RE: Riverside Plaza
Developer Response to PLUS review 2015-07-09
Tax Map: 2-34-29.00, Parcels 69.01, 69.08, 69.09, 69.10 and 69.11
DBF No.: 1541A006.xxx

On behalf of the Owner / Developer, Re/Max Realty, we are pleased to submit a response to the Office of State Planning's comments for PLUS Review 2015-07-09: Riverside Plaza. In accordance with the comments, we are providing a written response to the comments. Attached with this response is a revised preliminary site plan as part of the conditional use application.

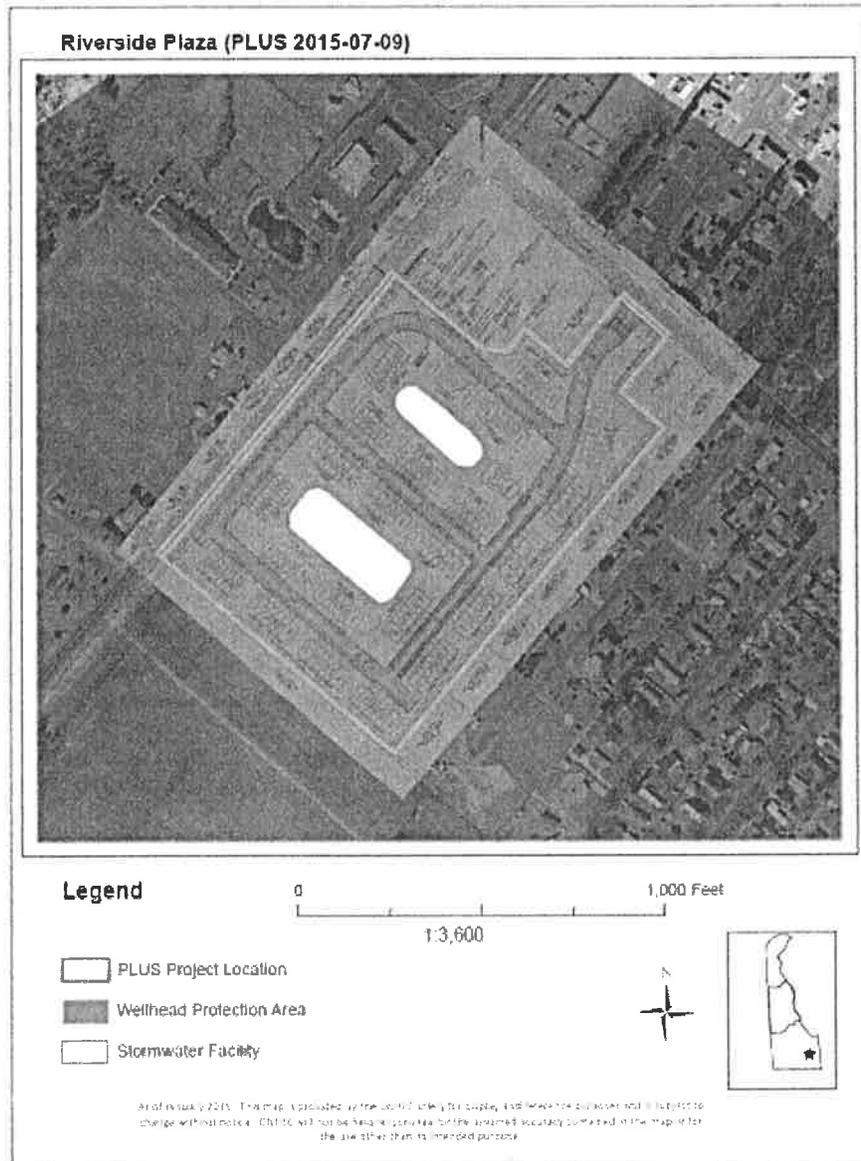
- *The DNREC Water Supply Section, Groundwater Protection Branch (GPB) has determined that the parcel falls entirely within a wellhead protection areas for Sussex County (see map). The wellhead protection areas protect well owned by Tidewater Utilities Inc. (TUI) Meadows District.*

Wellhead protection areas are surface and subsurface areas surrounding a public water supply well where land use activities or impervious cover may adversely affect the quantity and quality of ground water moving toward such wells.

The site plan shows infiltration ponds for the management of stormwater (see map below). While these systems address the particulate and nutrient components of stormwater runoff, they do not address pathogens, petroleum hydrocarbons, pesticides, other organic compounds, and other inorganic compounds associated with residential land use (DNREC, 1999). Because this is wellhead protection area, there exists the potential for these constituents to enter the aquifer and compromise water quality.

GPB recommends, advanced treatment for the stormwater management facility to address the dissolved pollutant load.

In addition, because the wellhead protection area is an existing source of public drinking water and the excellent ground-water recharge area so readily affects the underlying aquifer, the storage of hazardous substances or wastes should not be allowed within these areas unless specific approval is obtained from the relevant state, federal, or local program.

We acknowledge that the proposed project is located within the Wellhead Protection Area and the site will be developed to meet the requirements of Chapter 89 of the Sussex County Code. All stormwater management facilities will meet or exceed the DNREC sediment and stormwater regulations to include pre-treatment requirements.

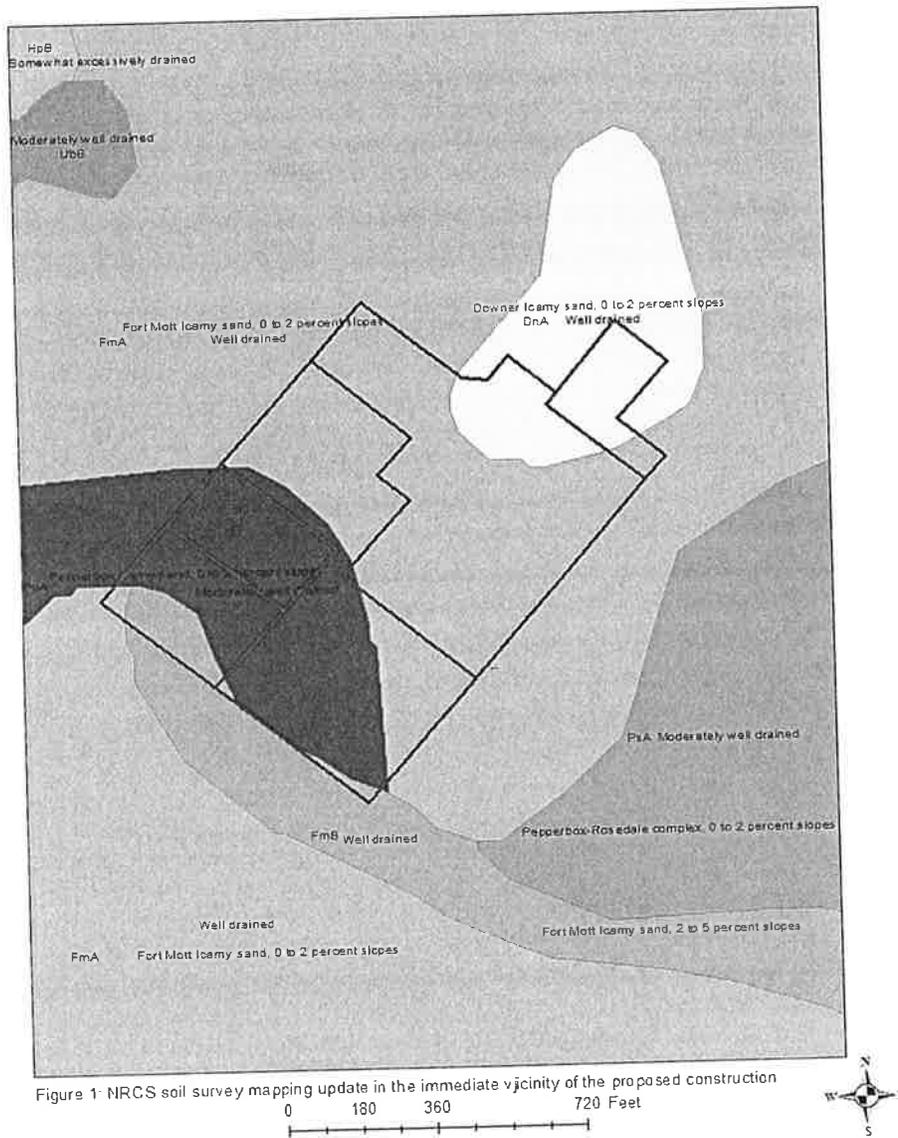
- *The soil mapping units mapped on subject parcel are all well or moderately well drained (Figure 1). These soil mapping units, generally, have few to moderate limitations for development.*

We are aware of the soils types and characteristics and will perform additional tests.
